**Area Plan Review
For
Superior Township, Michigan**

Applicant:	SB Invest LP
Project Name:	Timber Creek
Location:	Macarthur Blvd and Wiard Road
Plan Date:	February 20, 2026
Current Zoning:	Area Plan PC, Planned Community
Action Requested:	Area Plan Petition Approval-PC, Planned Community District

Regarding: **Timber Creek Flats
Area Plan Review
OHM Job No. 0140-25-1010**

SHEET NUMBER
C1-01

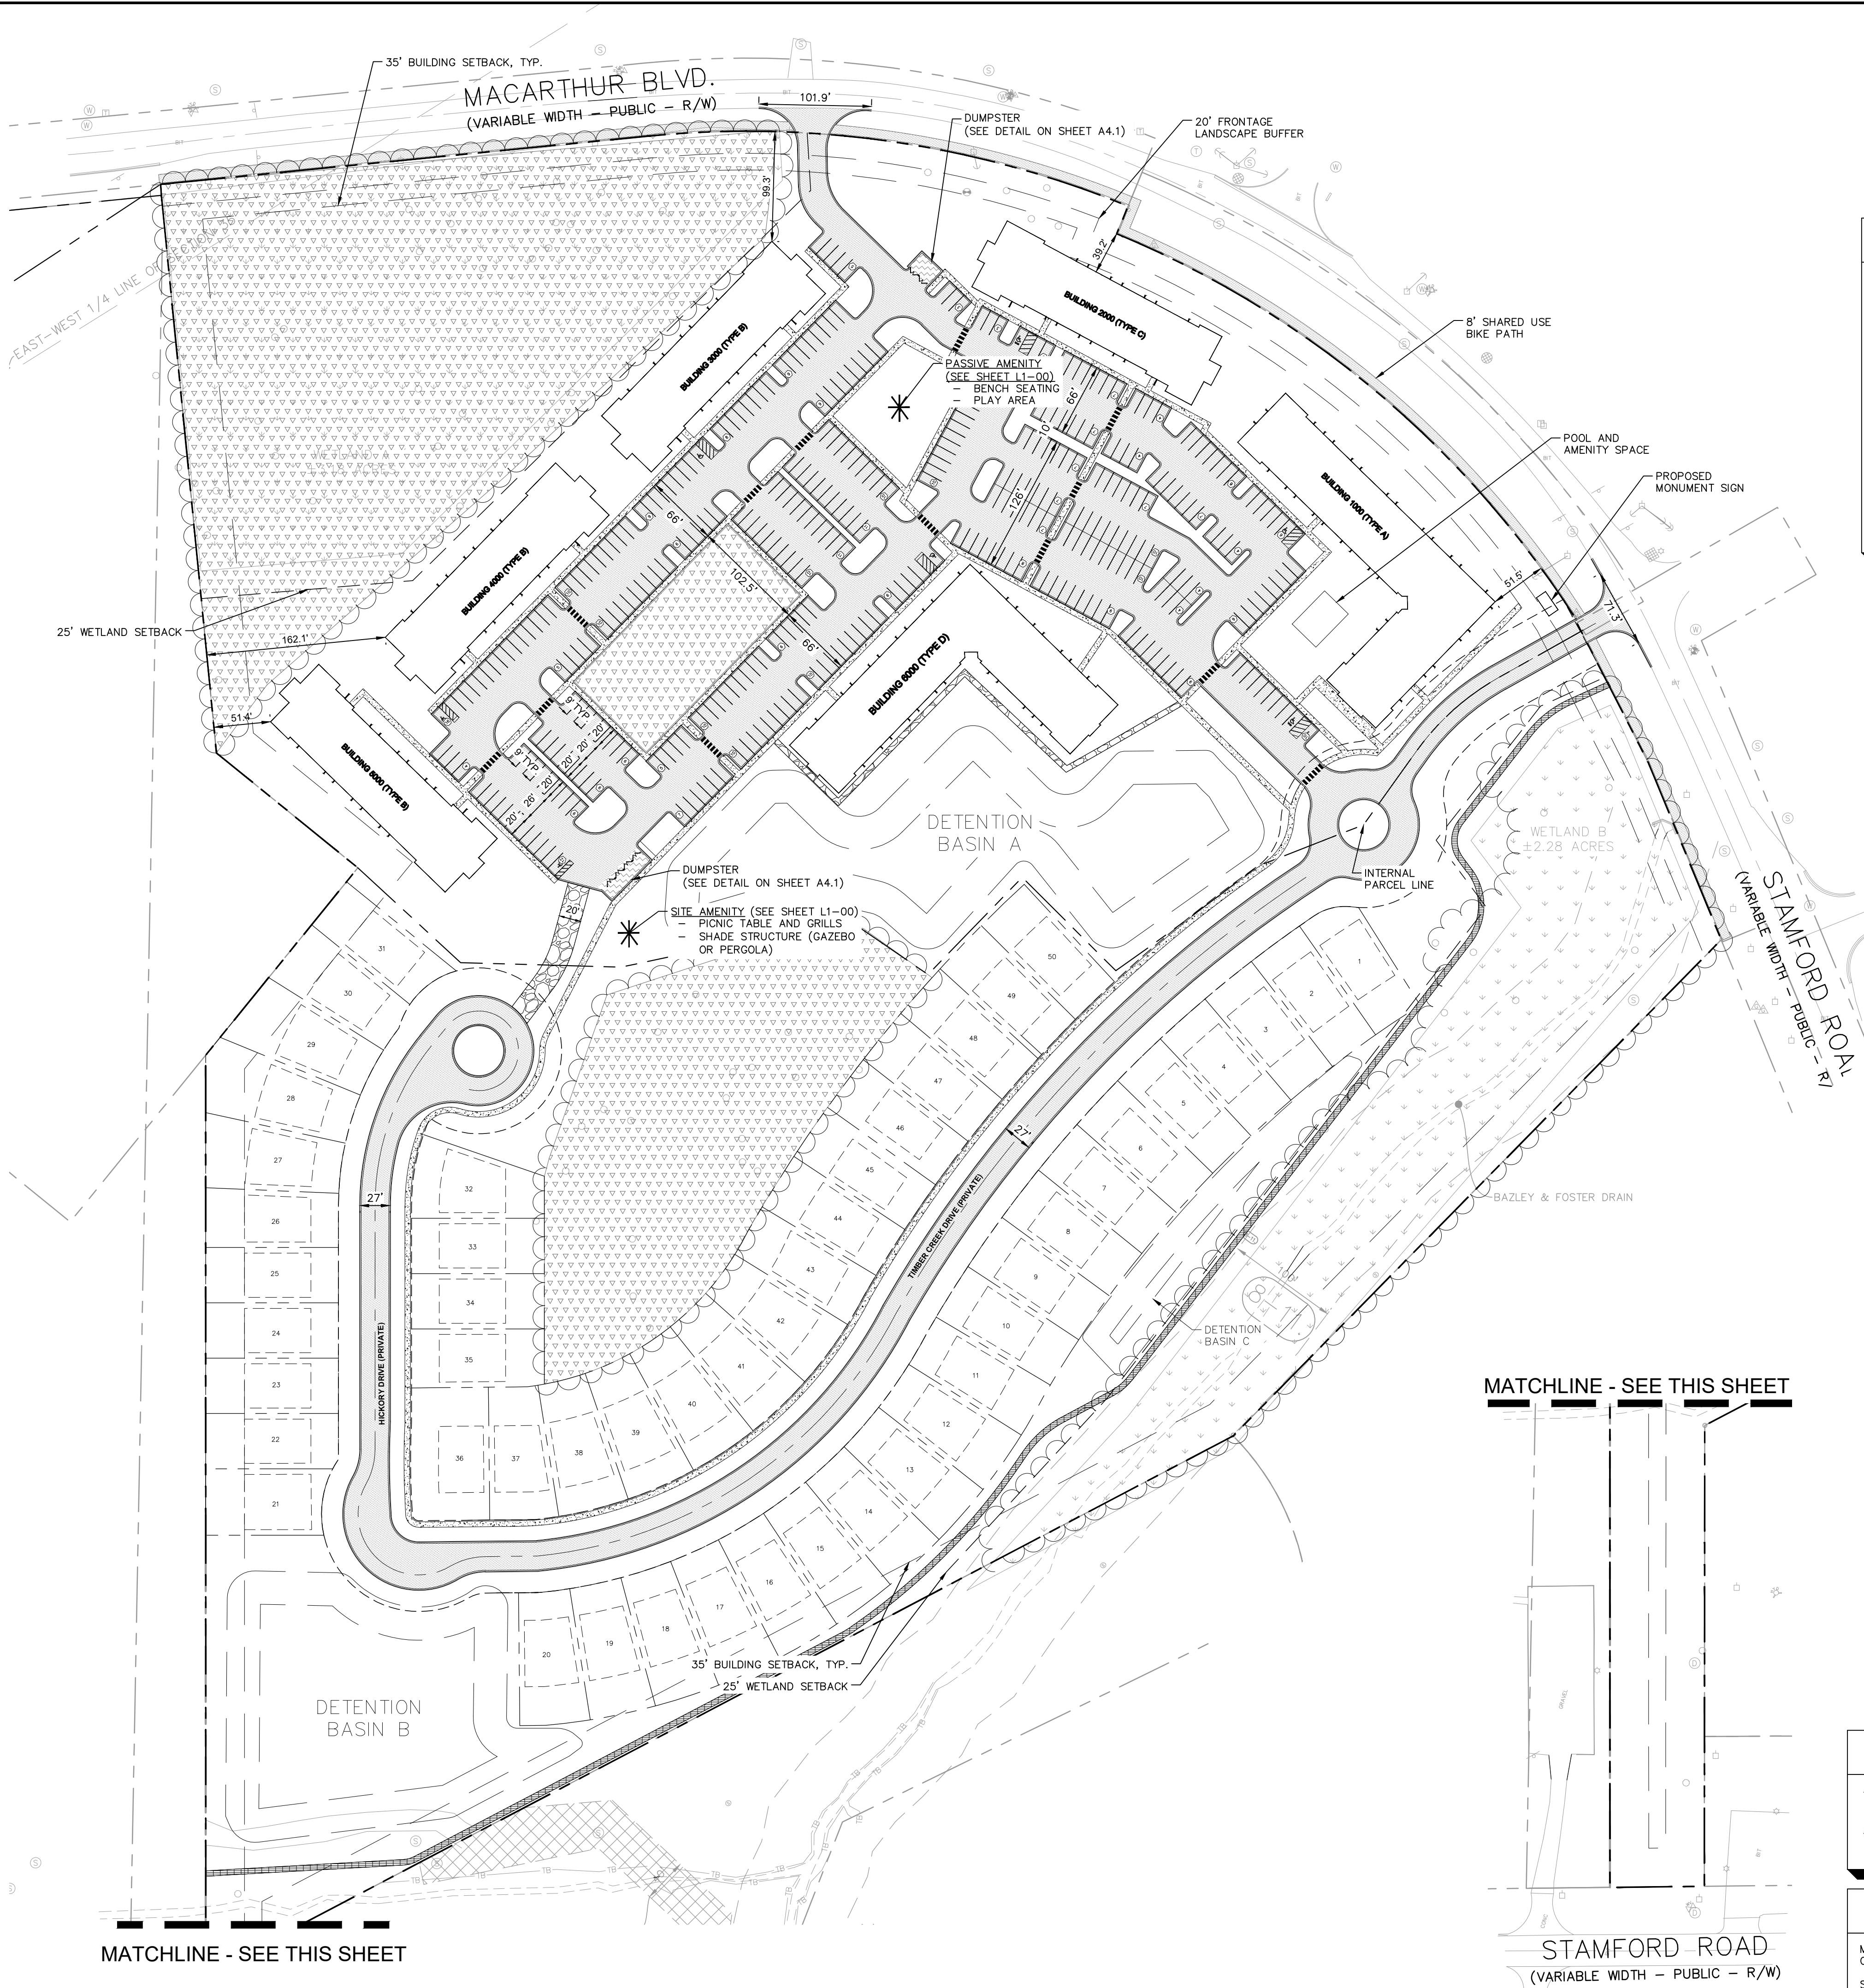
A major part of the layout is driven by preserved natural features. The narrative states that more than 33% of woodland areas are preserved, including a 1-acre interior tree preserve, and that approximately 5.5 acres of wetlands are preserved with no proposed impacts. These preserved areas create a strong open-space framework, especially through the west/central part of the site and along the eastern edge. See overall site plan, Sheet C2-200 and natural feature plan C1-01.

SHEET NUMBER
C2-00

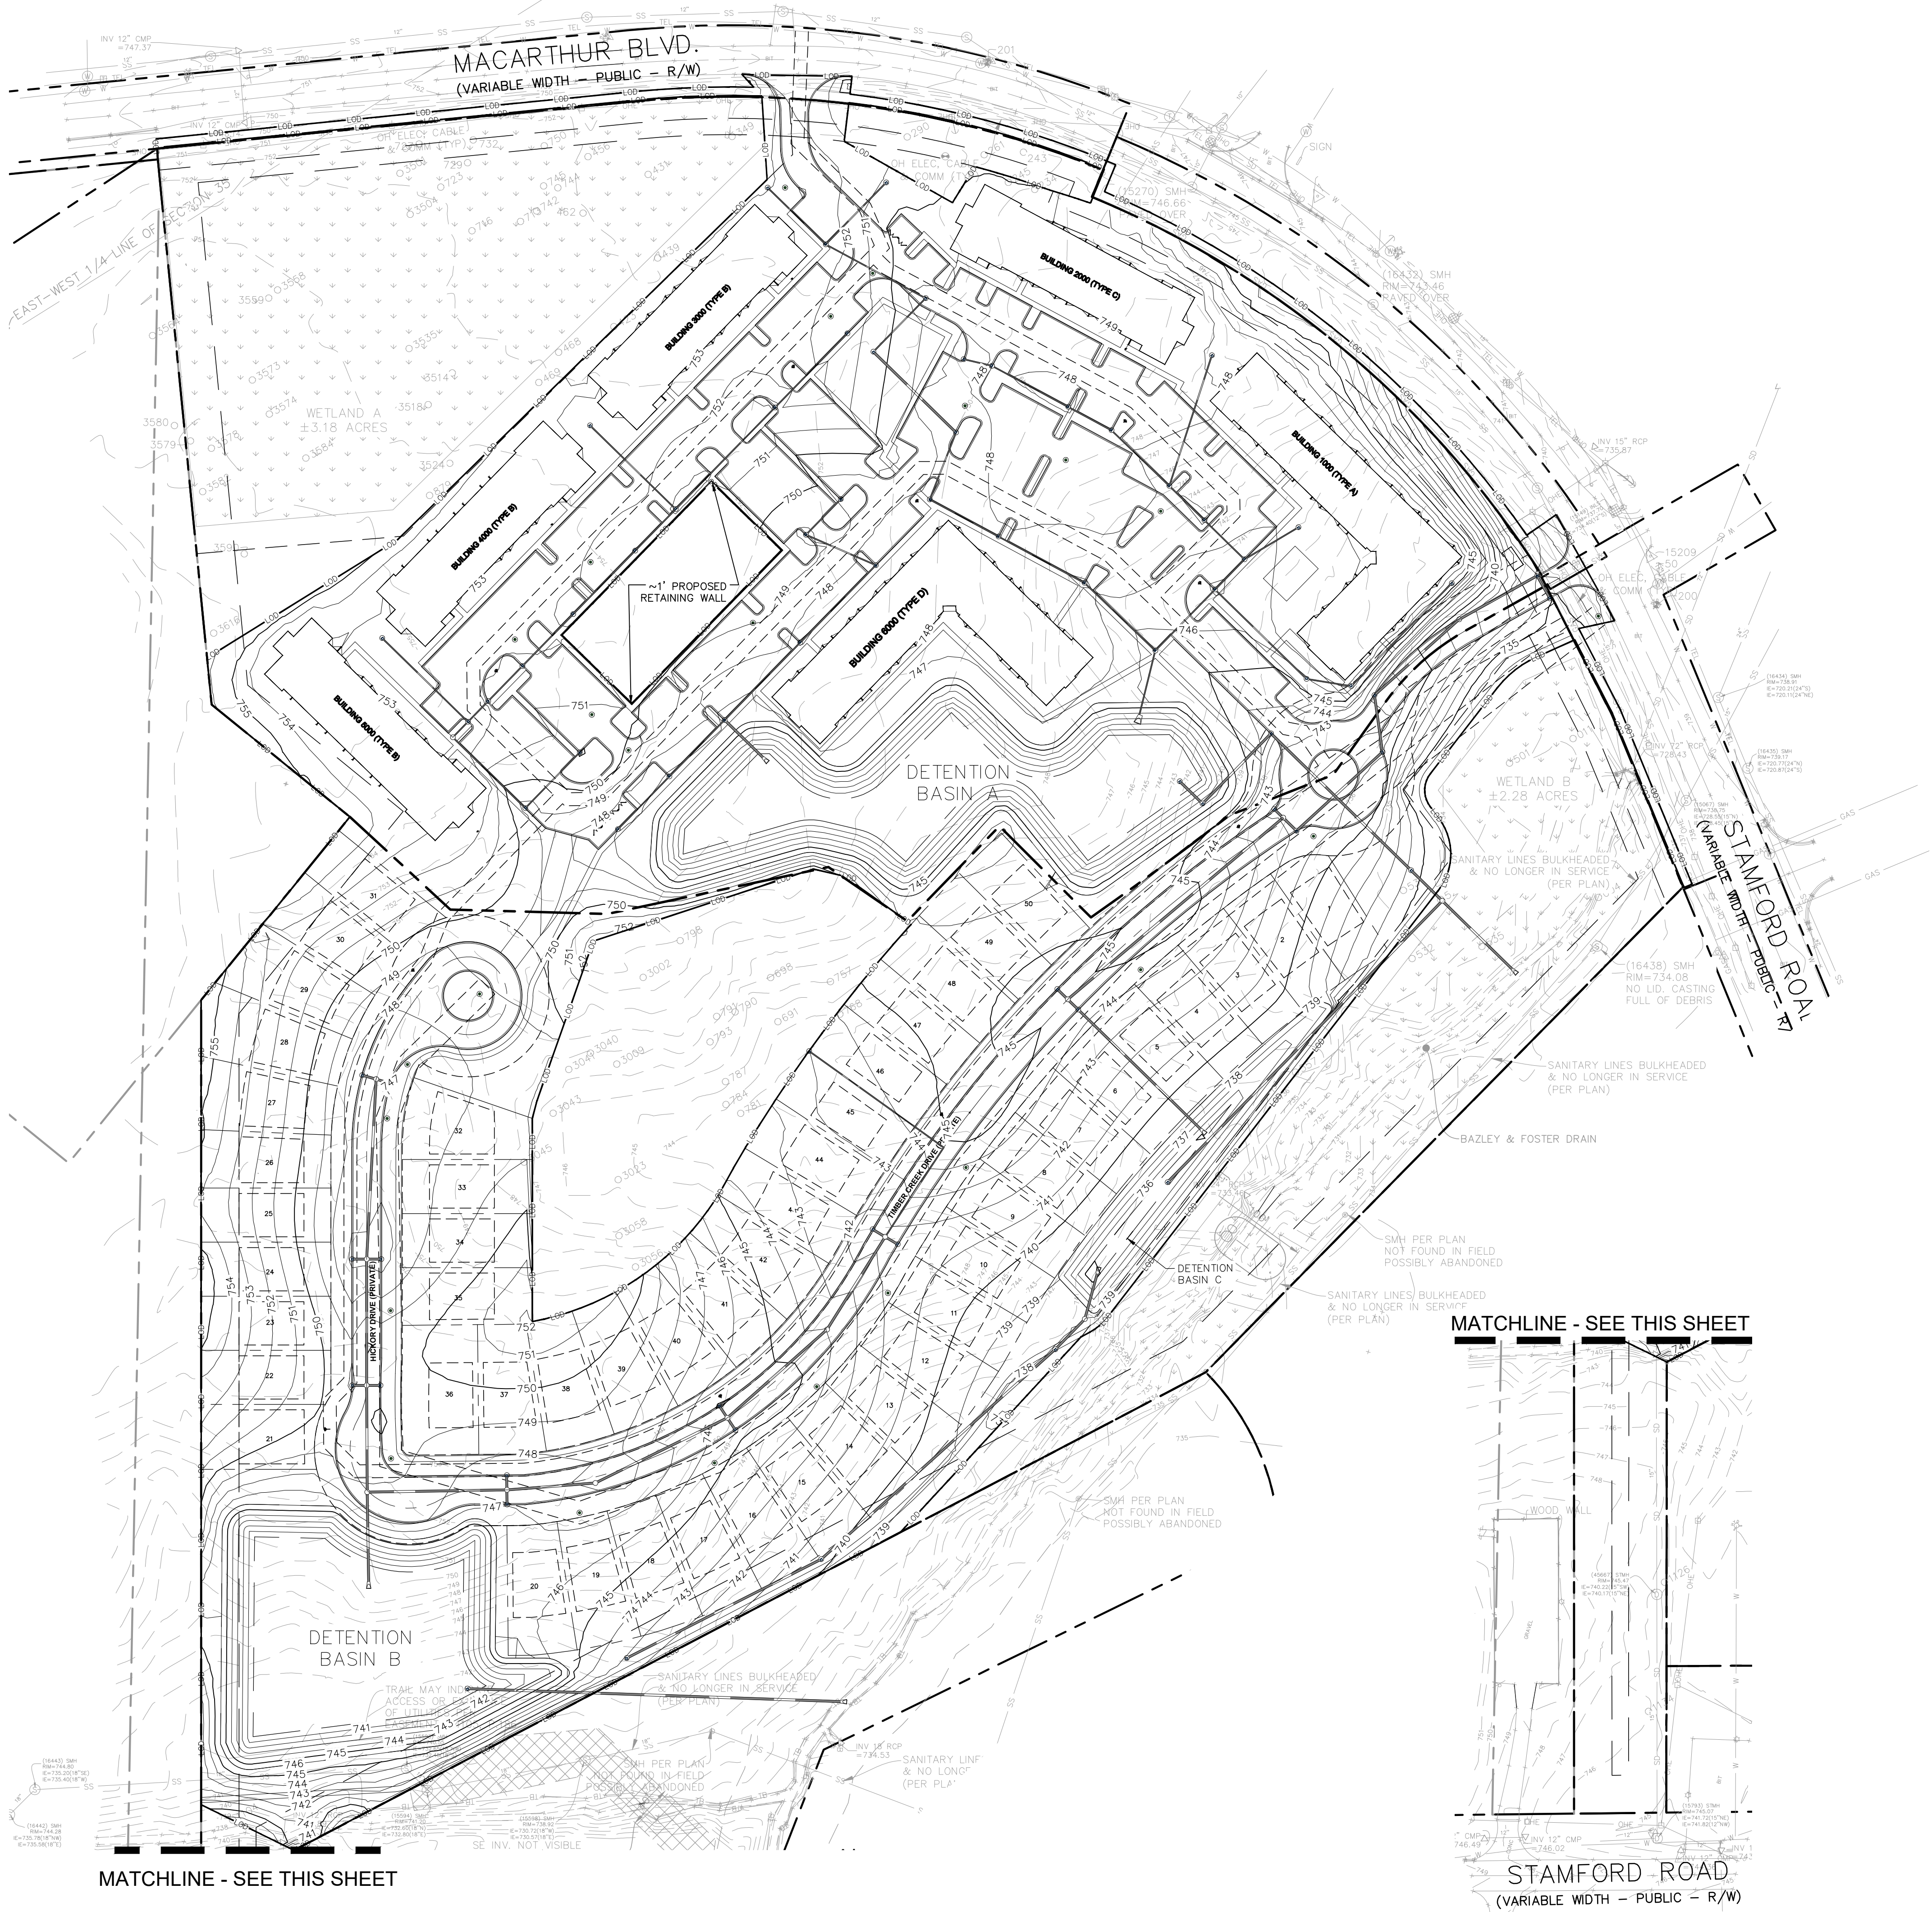
We have encouraged the applicant to orient the primary building frontage toward Macarthur Boulevard. However, the previous concept plan included townhomes along Macarthur that helped break up the building massing. The applicant should provide a visual representation showing how the building massing will appear from Macarthur Boulevard and, if necessary, revise the design to further break up the massing of the buildings fronting Macarthur. See the cover narrative and overall site plan, Sheet C2-200.

The landscape plan also shows pedestrian/open-space connections through the site. Detention basins are distributed throughout the development and are integrated into the open-space system rather than isolated at the edges. See overall site plan, Sheet C2-200, and overall landscape plan, Sheet L1-00.

1 BLDG TYPE "B" - FRONT ELEVATION
A2.2 3/32" = 1'-0"

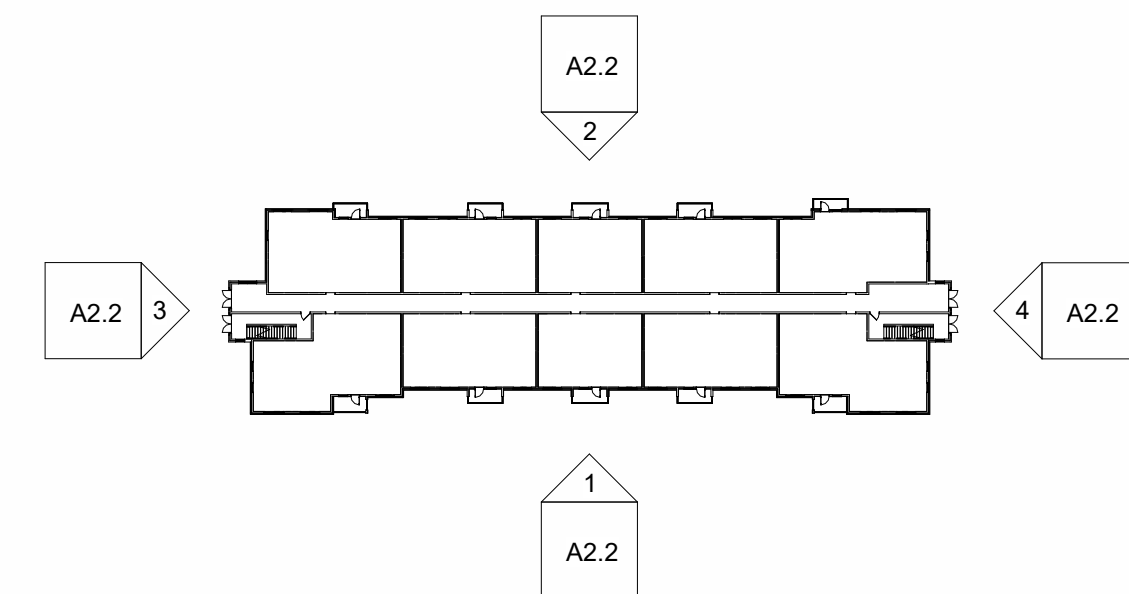
It's not clear from the floor plans and architecture how Building A and Building B front elevation interact with McArthur Boulevard. Are there accessible doors or entrances facing Macarthur Boulevard? Are there design elements that make this appear and serve as a front elevation? How does the building relate to McArthur Boulevard?
